09 May 2013

The Director  
Karen Jones  
Metropolitan & Regional Projects South  
NSW Department of Planning & Infrastructure  
GPO Box 39  
SYDNEY NSW 2000

**Subject: State Significant Development Application for a staged mixed use development comprising residential, commercial, retail, community and open space uses at The Haymarket (Concept Proposal) (SSD5878)**

7428A MOD AR D397 01/03/2013	DENTON CORKER MARSHALL	THE HAYMARKET LEND LEASE DEVELOPMENT	DEVELOPMENT APPLICATION PEAK TOWER - NORTH ELEVATION PROPOSED BUILDING PROFILE OVERLAY
1:1000 @ A3 0 10 20 30

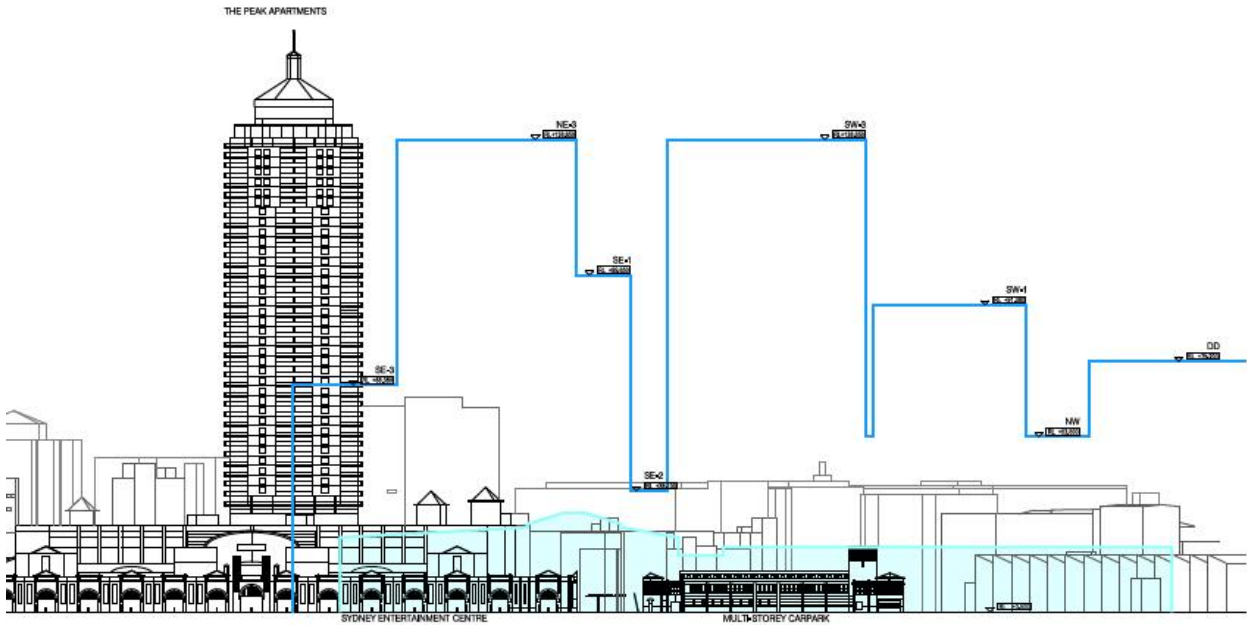
The loss of amenities, outlook and views is an excessive burden on the residents of the Peak and for all the residents of surrounding buildings. At a minimum, it is imperative to delete the Tower SE1 from the planned development.

The following figure – buried in SSD 5755 illustrates the size of the proposal in relation to The Peak.

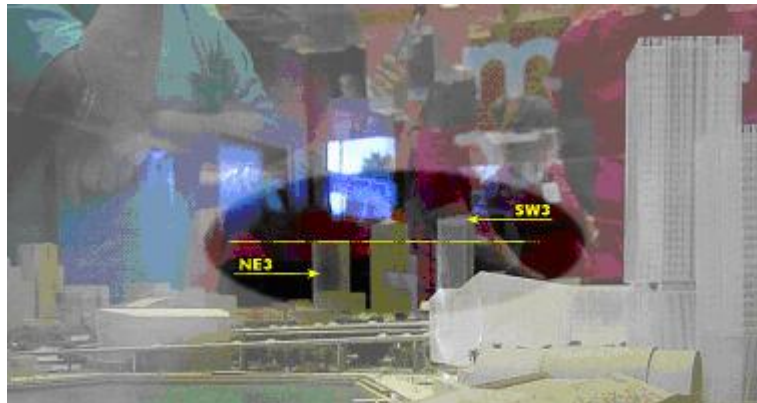
- There will be some impact on the Darling Harbour Rail Corridor resulting from the loading dock associated with the Exhibition. The impact of the loading dock is, however, limited and will not affect interpretation of the Rail Corridor or its heritage significance. The impact will be ameliorated by the removal of monorail infrastructure by others;*

So there will be some impact

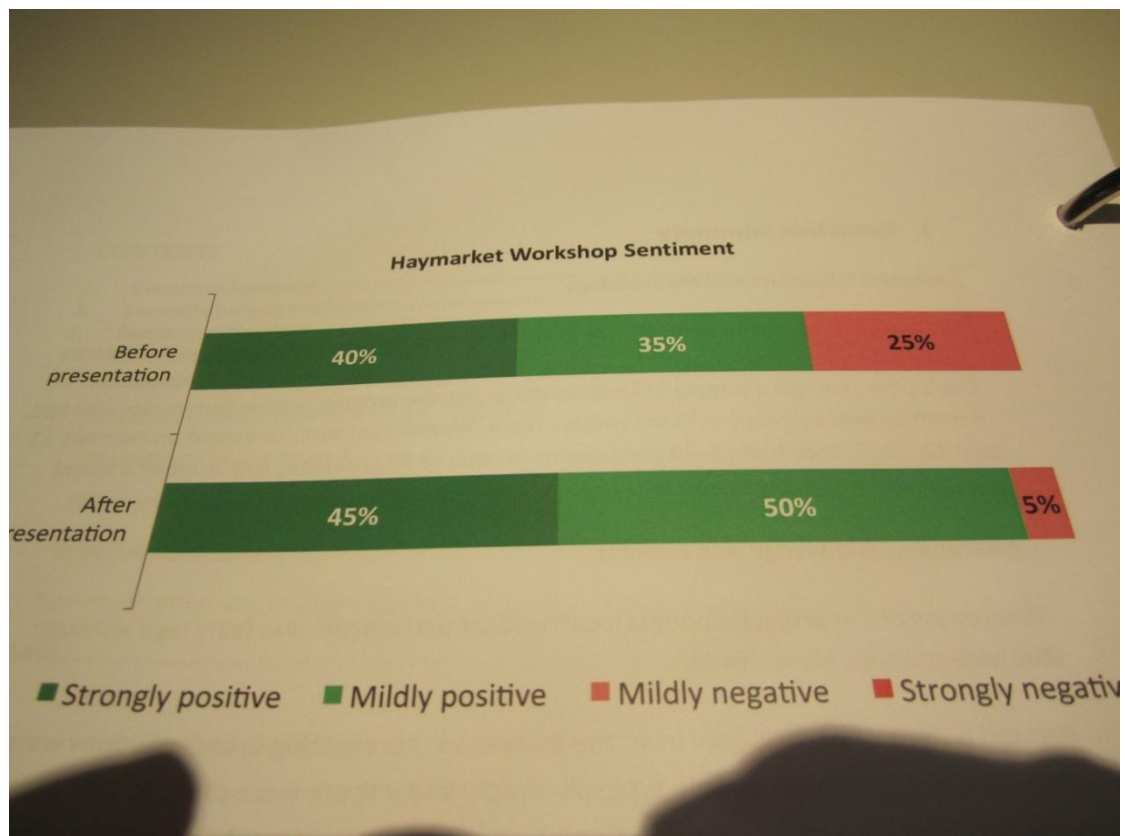
The information given during consultation was very much smoke and mirrors. The statements given on the height of the towers was vague and variable with the number of floors being defined from the podium level in some cases. The RLs of the top of the towers were not disclosed prior to the EIS being lodged. In fact tower NE3 grew about 8 floors after consultation. This is clear from photos of the original model.
